RE: Objection to Planning Application HGY/2024/0921 - Unacceptable Quality of Accommodation

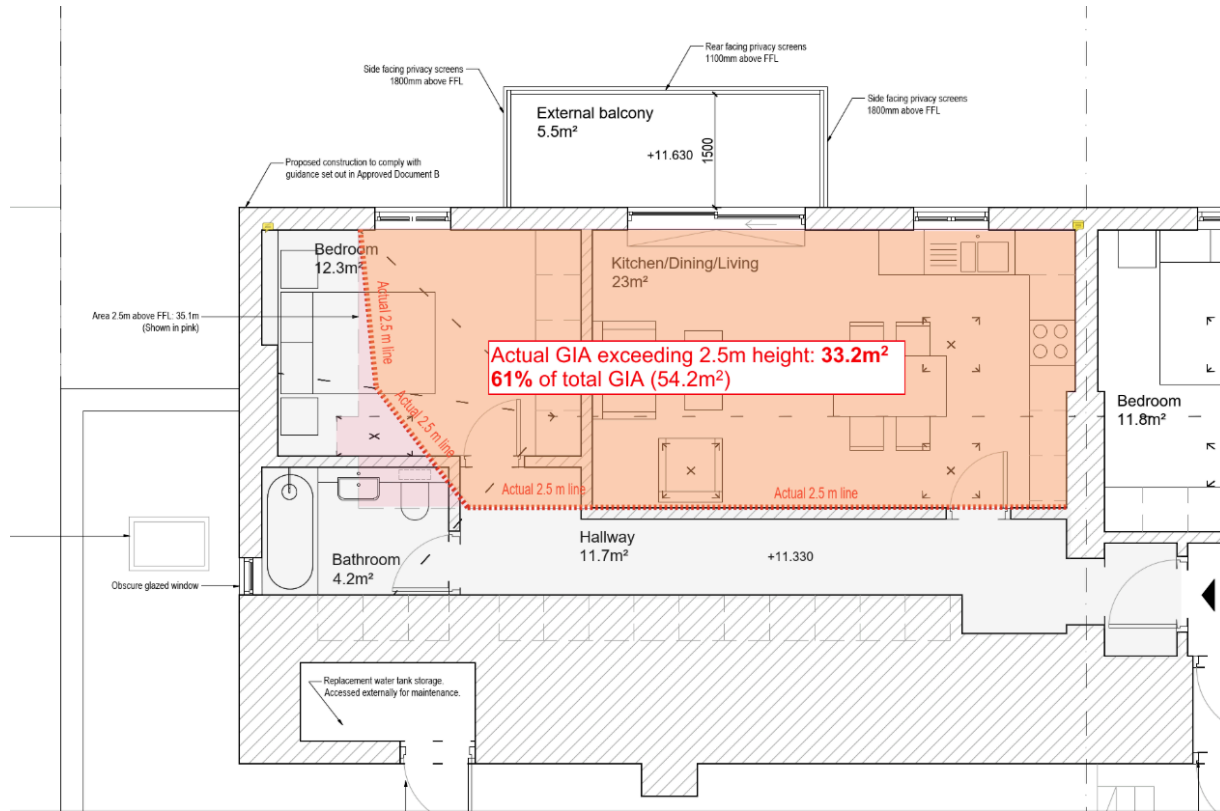
1. Non-Compliant Ceiling Heights (Breach of London Plan Policy D6): According to the applicant's revised 'L3' and roof plans, Flat 9 fails to meet the minimum ceiling height requirements mandated by London Plan Policy D6. The policy requires that at least 75% of the Gross Internal Area (GIA) must have a floor-to-ceiling height of 2.5m.

The shaded area of ceiling height exceeding 2.5m indicated on the applicant's plans is incorrect; it is geometrically impossible for the shaded area to remain orthogonal at the points where it intersects with the roof fold lines. The marked-up floor plan below illustrates the corrected shaded area, which shows the area with a ceiling height exceeding 2.5m is actually ~33m². This constitutes only 61% of the flat's GIA, falling substantially short of the 75% minimum requirement set out in Haringey's adopted policies and the London Plan:

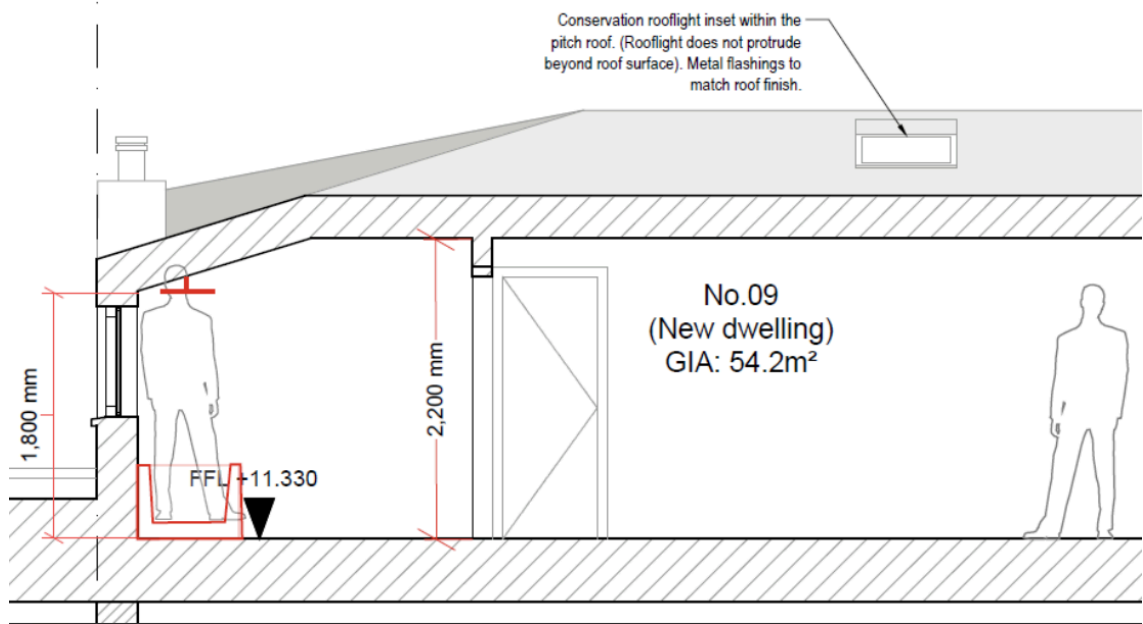
2. Unusable Amenities due to Restricted Headroom: The cross-sections provided demonstrate that the reduced ceiling heights render essential facilities potentially unusable:

- Shower:** The shower/bath is positioned under the sloping roof eaves. According to the proposed section, it appears there is insufficient standing height for a shower user. This effectively means that as proposed, the flat may not have a functional shower, falling below acceptable living standards.

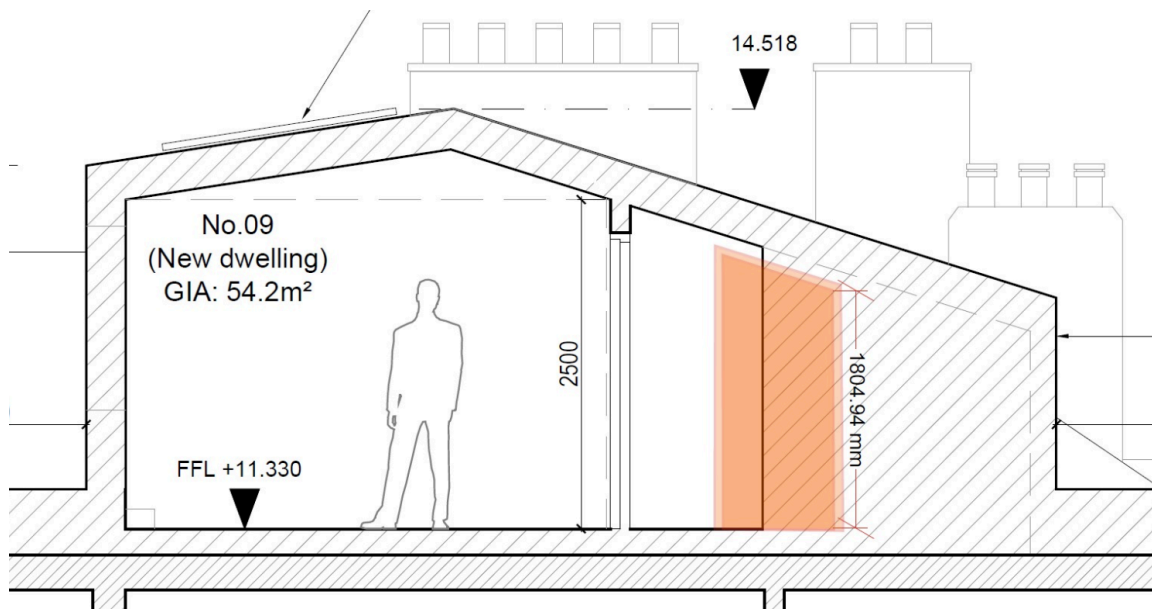
- Un-openable Front & Other Doors:** The proposed reduced height entrance door to Flat 9 clashes with the sloping roof soffit. The door is physically unopenable as drawn because the head of the door leaf conflicts with the angled ceiling immediately inside the entrance.
